I-195 Washington Bridge (700)

Forensic Evaluation and Procedural Audit Related to PT Tie-Down Failures

I-195 SB Washington Bridge over Seekonk River
Providence, RI

DRAFT REPORT

Figure 20. Link Slab and Joint Location Plan for Contract 2021-DB-020 (Sheet 61 of IFC Submission, I-195 Washington North Phase 2 Rehabilitation, Volume 4).

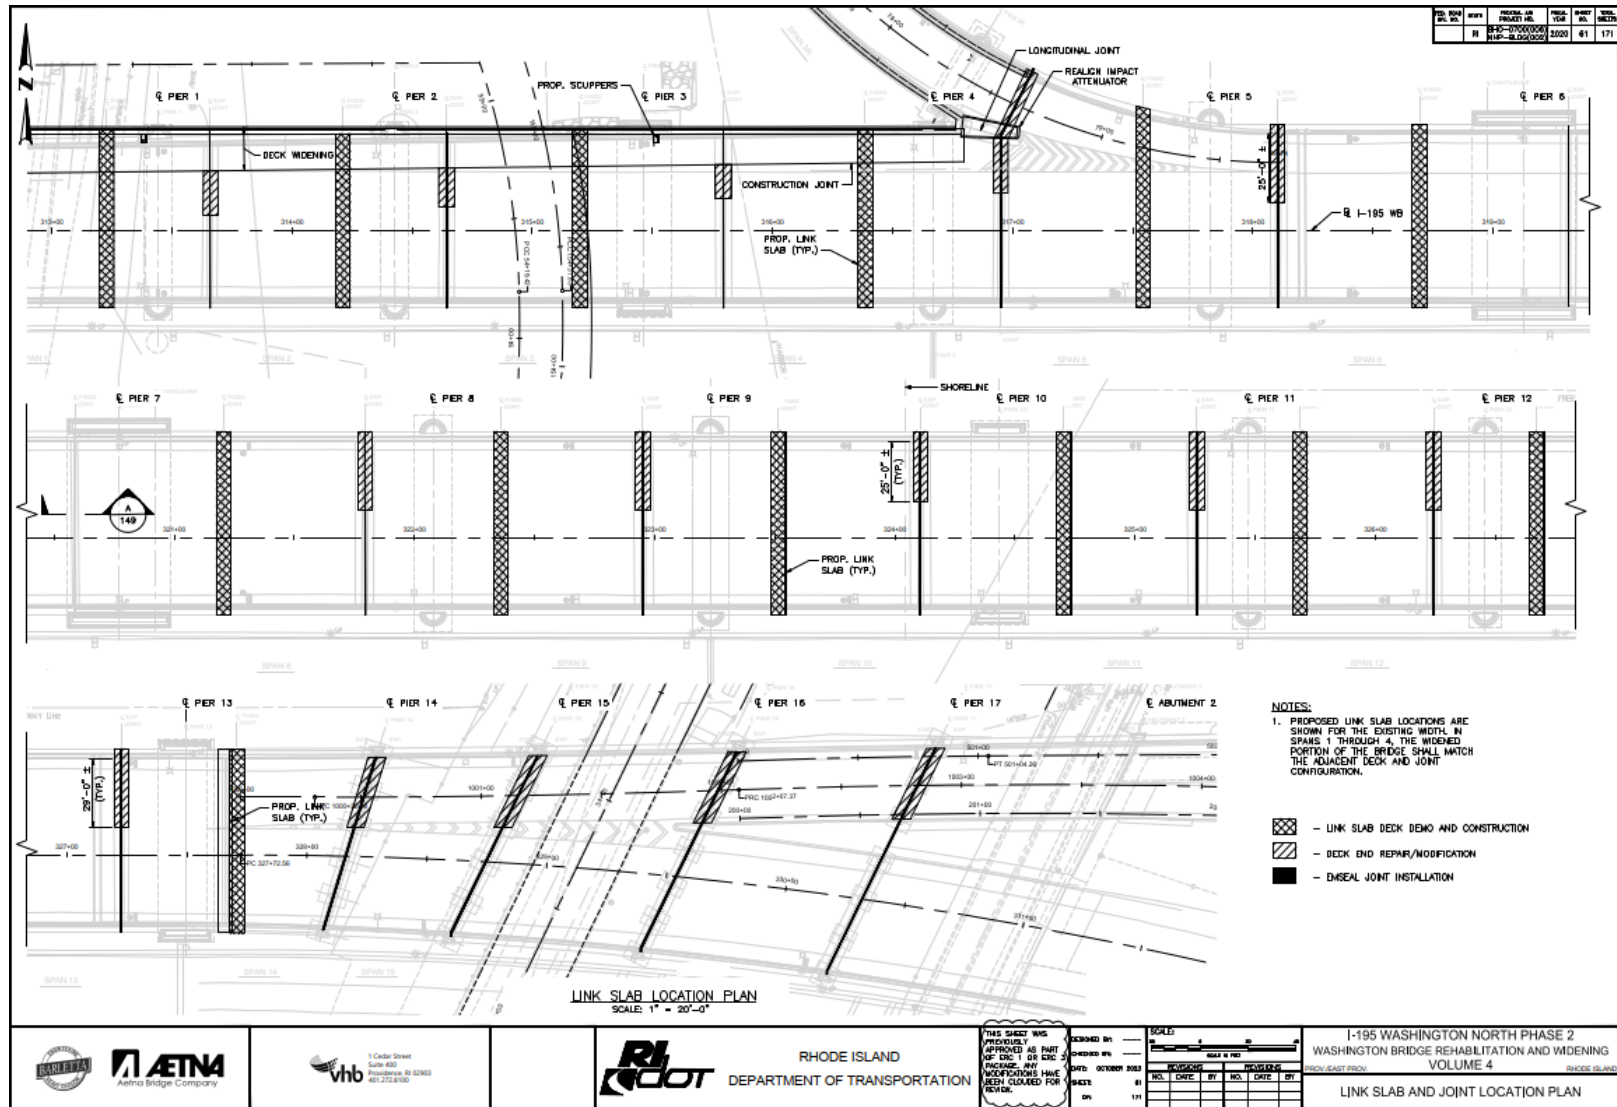
The design under this DB followed largely the scope of the 2016 project, to include cantilever repairs, link slab installation, and FRP strengthening. However, the link slab locations were revised to closer reflect the Scenario #1 concept under AECOM's Final Technical Evaluation Report, wherein alternating joints were replaced with link slabs and with Emseal joints, thereby reducing the number of link slabs to be installed and the number of spans over which the deck would be continuous. In VHB's design, 14 link slabs were to be installed, rather than 23 (Figure 20).

With regard to Piers 6 and 7 in Span 7, the joints at the concrete cantilever to steel superstructure transition at the pier walls were retained. The deck joints above the first cantilever corbel-to-drop-in beam support from the Pier 6 and Pier 7 pier walls in Span 7 were to be replaced with a link slab (Figure 21). The effective length of continuous deck increased from about 63'3" to 120'6", or approximately double. Figure 22 shows the intended details for the joint demolition and link slab installation at the drop-in spans. Figure 23 shows a concrete repair detail in the vicinity of the Pier 6 and Pier 7 cantilever tie-down connections.

Figure 24. Excerpt regarding Abutment 1 cantilever restraint from IFC Calculations²⁰

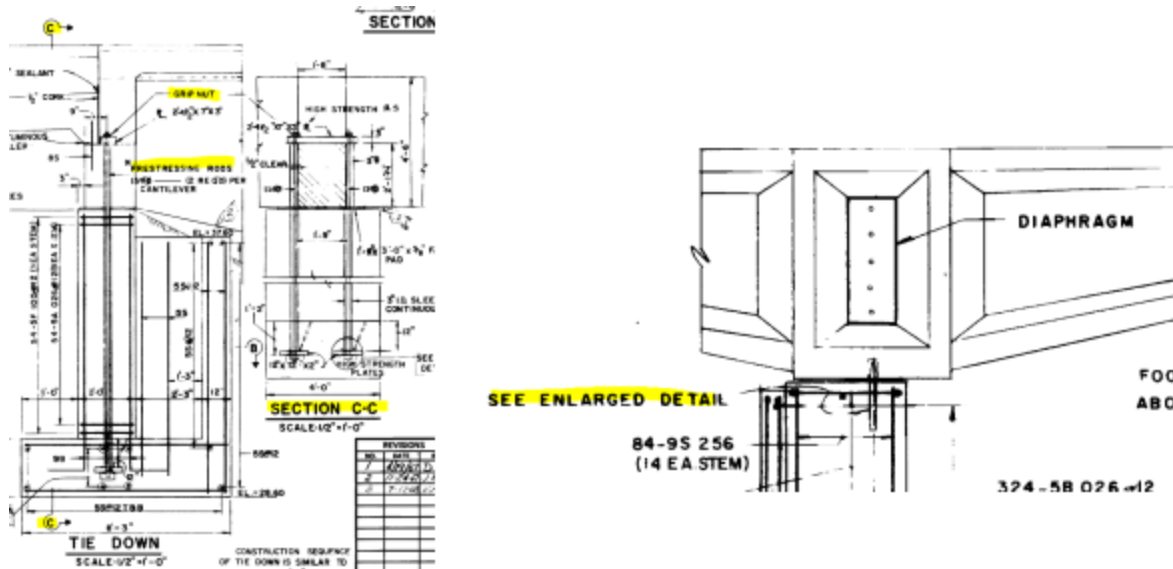
The west end of the PT beam located at Abutment 1 is restrained against uplift via a Tie Down detail consisting of prestressing rods cast into reinforced concrete and held in place by high strength steel plates attached to the rods via tightened nuts at either end. The result is a system that restricts lateral and vertical movement of the PT Beam end with respect to the supporting cantilever stem. Additionally, the base of the PT beam is restrained from moving laterally via a tapered steel down rod, but not significantly restrained against rotation.

Figure 24 was included as part of this passage and shows the Abutment 1 tie-down detail and the cantilever beam support and pintle detail (highlights by VHB). No similar discussion is presented in the IFC calculations for cantilever tie-down locations at Piers 6 and 7.

Figure 37. Link slab placement timeline

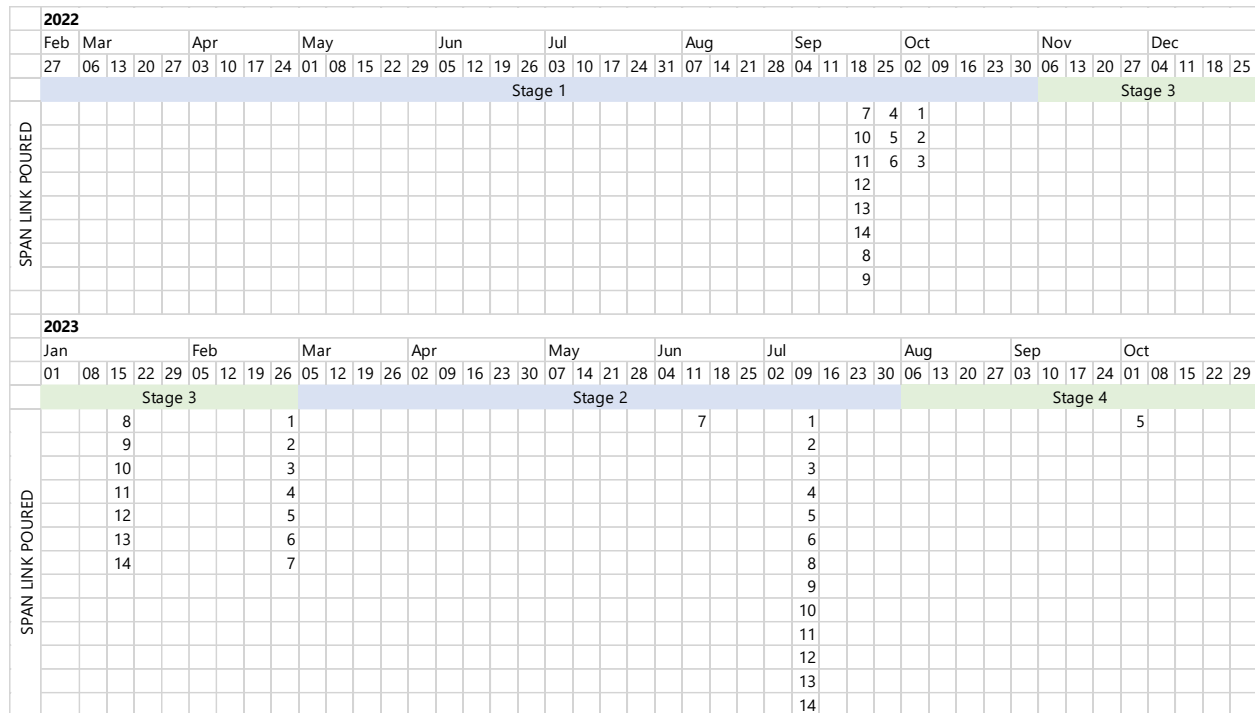
The two fractured rods were discovered during December 2023. The sequence of link slab closures is illustrated in the timeline of Figure 37. Specifically, closures for Span 6 (adjacent to Pier 6) occurred in September 2022, February 2023, and July 2023. Likewise, Span 7 closures (adjacent to Pier 7), occurred in September 2022, February 2023, and June 2023. The exact time of the fractures cannot be determined, but they were not observed during the July 2023 routine inspection. WJE's forensic evaluation noted that the thickness of corrosion product on the fractured surfaces suggests the fractures had not occurred very close to the time of discovery. However, it is likely fracture occurred within the timeframe that the link slabs were placed.
